INITIAL FIRE SAFETY INSPECTION REPORT

Factory Name: GREEN ARROW SWEATER IND.LTD.

Date: 25-August-2025

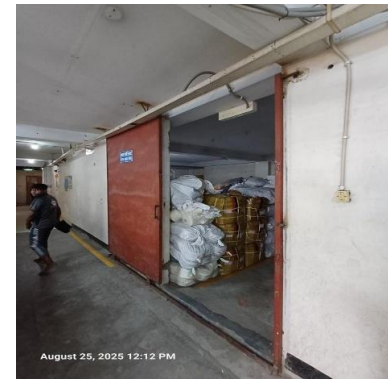
3	Fire Rated Construction	<p>Penetrations through floor/ceiling assemblies are found unsealed due to the plumbing pipe in the toilet area, and electrical cable on the 1st floor to 2nd floor.</p> <p>Production Building</p>	<p>Seal all penetrations and openings in floor/ceiling assemblies by a listed through-penetration fire stop system tested in accordance with ASTM E814 or approved alternative standard to maintain minimum 3-hr. fire resistance rating. Installation shall be as per manufacturer published installation guideline and the certification authority guideline to ensure the fire-rating in accordance with section 4.7 of RSC Technical Guideline (Standard)</p> <p>Or,</p> <p>Provide a minimum 2-hr fire rated shaft to separate the penetration from each floor if required.</p>	Within 3 Months
---	-------------------------	--	--	-----------------

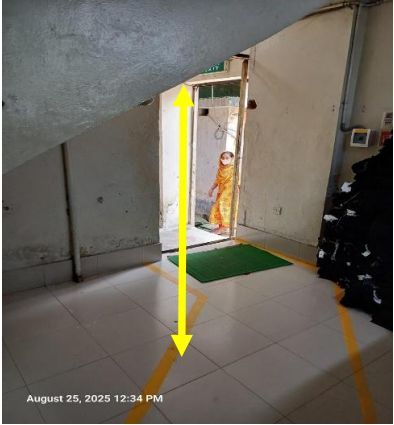
12	Fire Rated Construction	<p>Compressor is not separated on the 3rd floor in production building and in Shed-1 (Washing shed).</p> <p>Location: Shed-1 (Washing shed).</p>	<p>Compressor or other heat producing equipment shall be separated from other occupancies by a minimum 1-hr fire rated construction (wall, floor, slab etc.). Seal all penetrations and openings (door, window etc.) should be protected by 0.75-hr (45 min) fire rated materials to maintain the fire separation if required. All exhaust systems shall discharge to the exterior of the building in a safe location.</p> <p>Or</p> <p>Relocate it to exterior of the building and maintain a minimum 3m (10 ft.) spatial separation distance from the building. Boiler room separation shall meet section 3.4.2.1.2 of RSC Technical Guideline (Standard) .</p>	Within 3 Months
----	-------------------------	---	---	-----------------
